Addendum #1 File # 19-99373 Project

LAKEWOOD WATER TREATMENT PLANT FILTER BUILDING ROOF REPLACEMENT

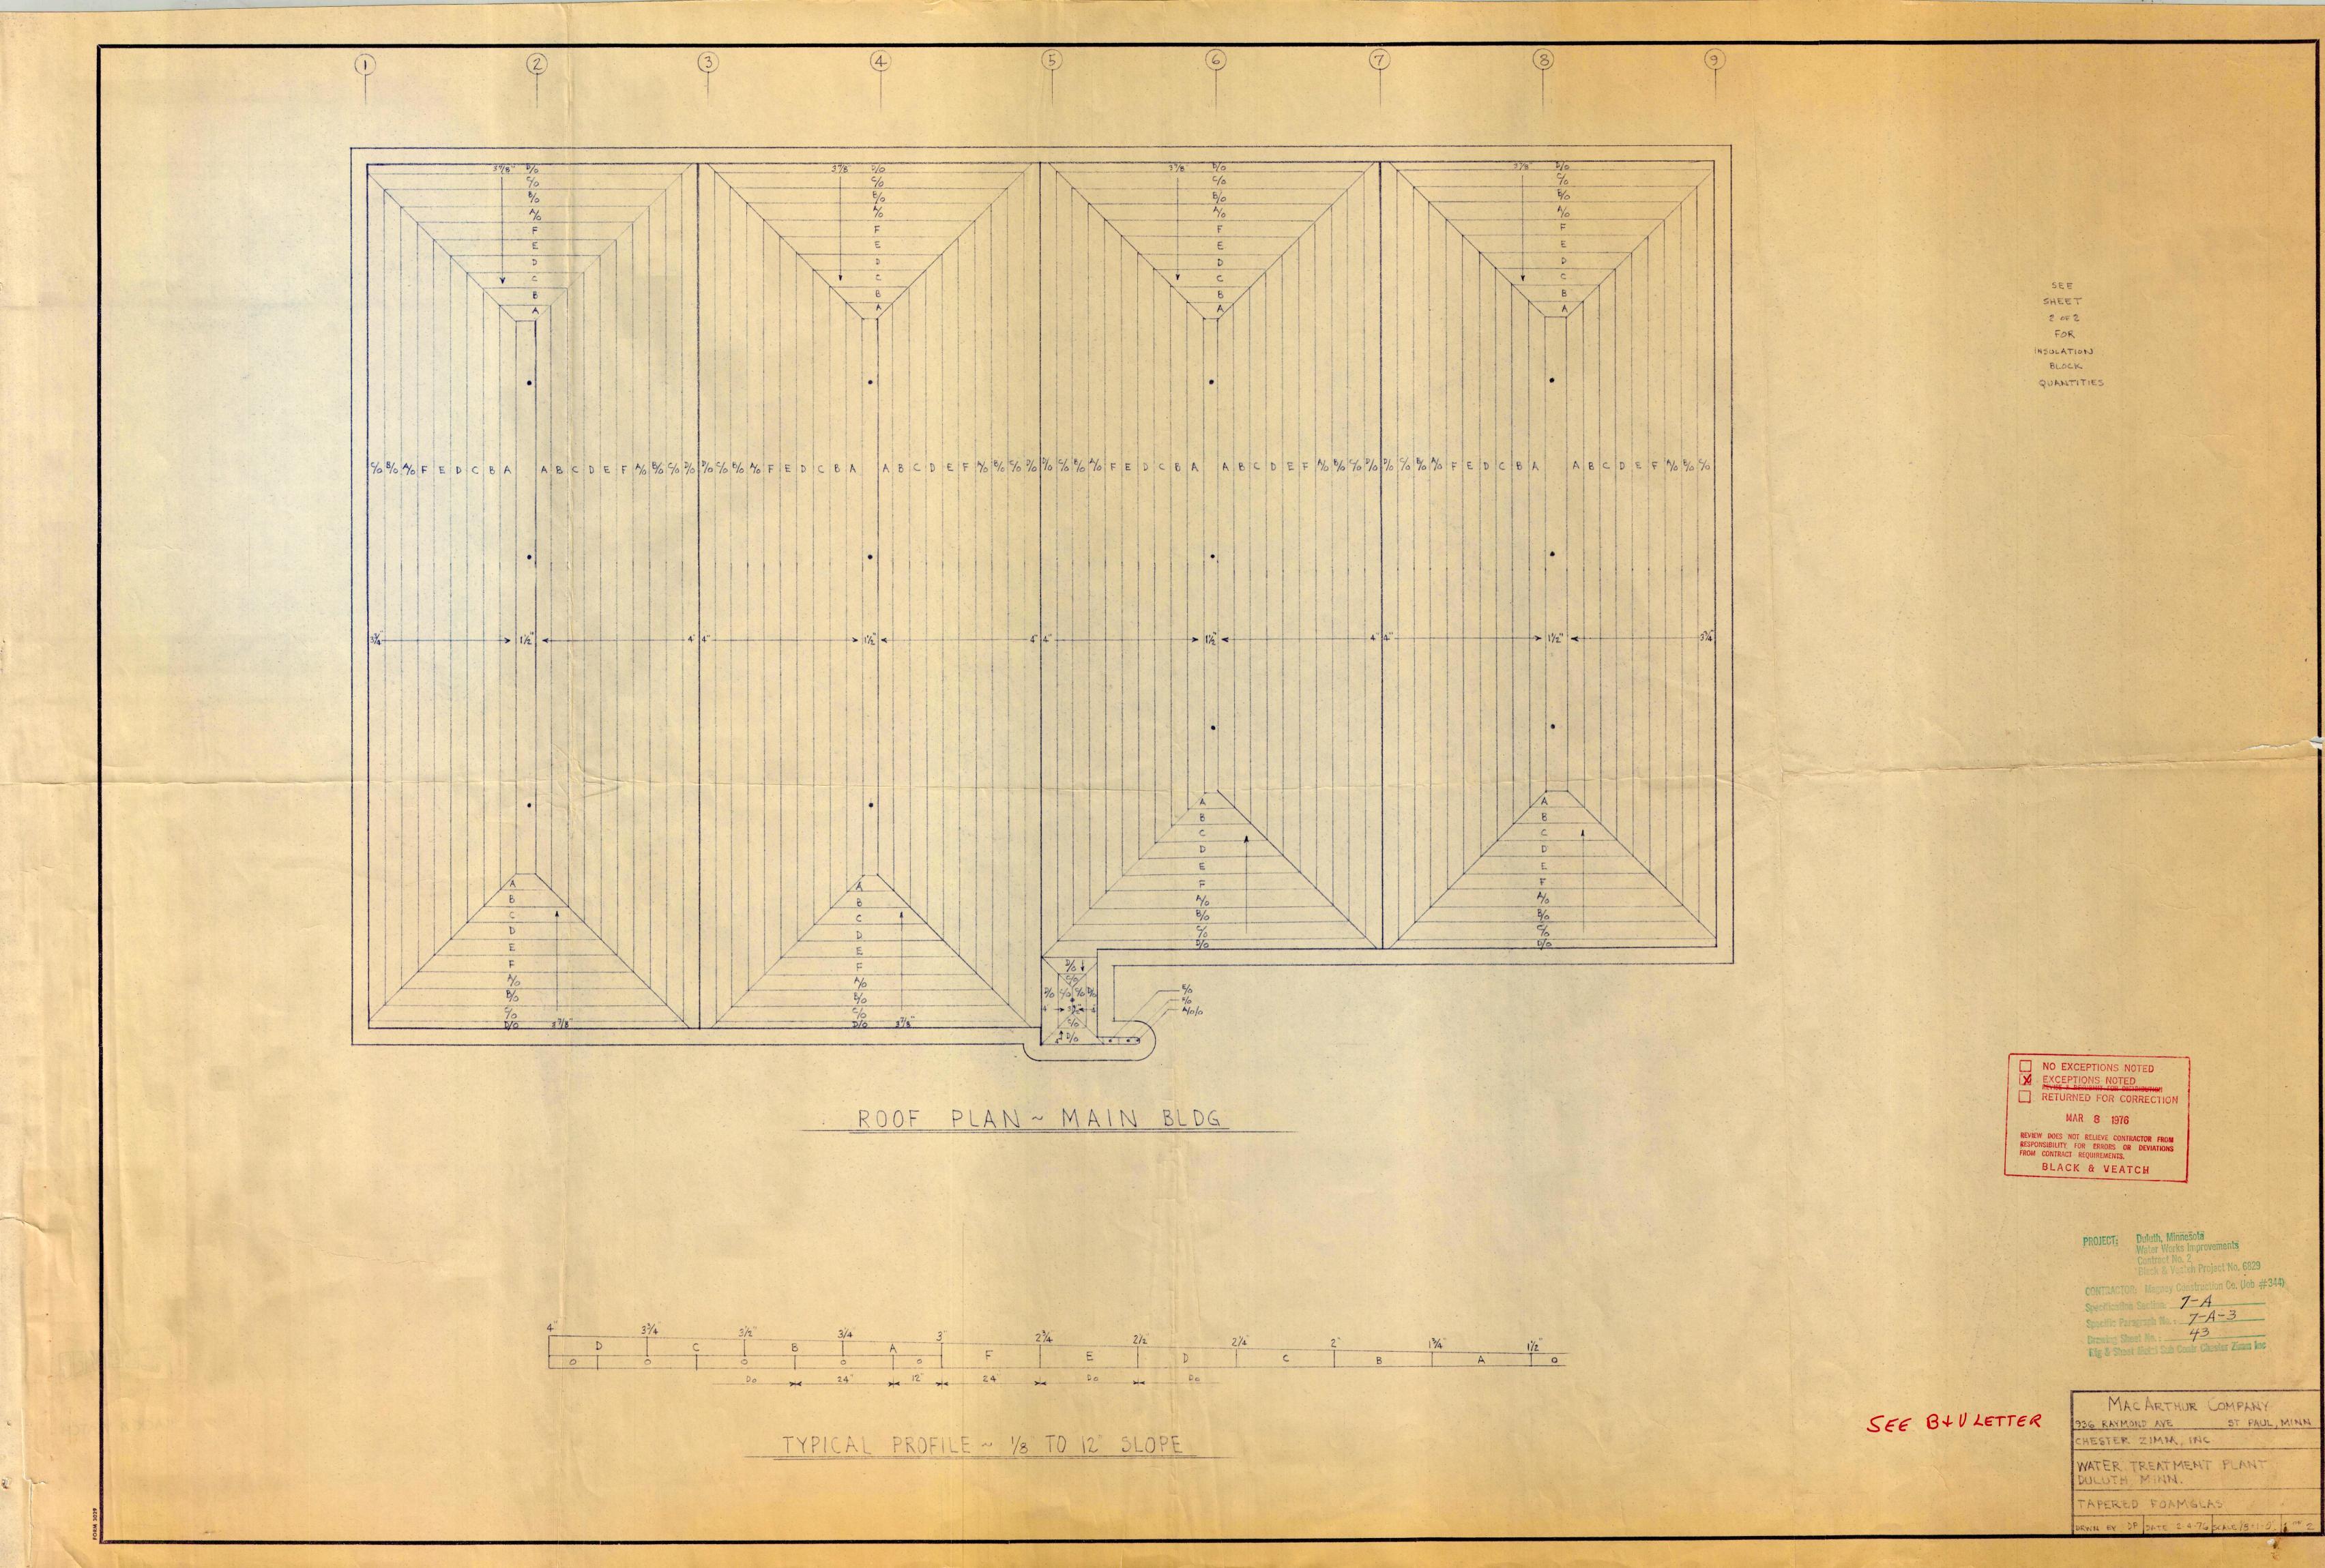
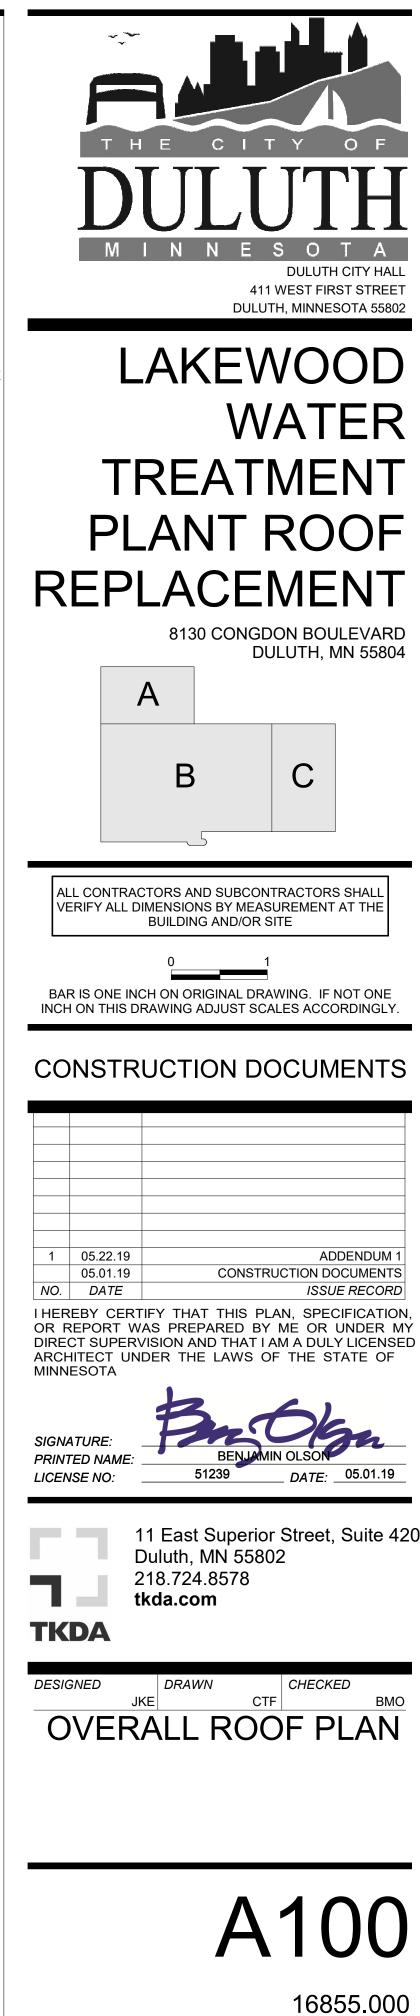
- 1. There was an error in the body of the bid advertisement. Bids must be submitted electronically at <u>www.bidexpress.com</u> or (for paper bids) to the City purchasing office by Thursday, May 30, 2019 at 2:00 p.m.
- 2. An updated A100 plan sheet is attached which has been revised to add (2) overflow scuppers to Roof Area C, one to the north and one to the south and a note clarification on the new roof assembly.
- 3. The existing shop drawing for Roof Area B, showing insulation depths and slopes, is attached.
- 4. The sign-in sheet from the prebid meeting held on May 22, 2019 is attached.
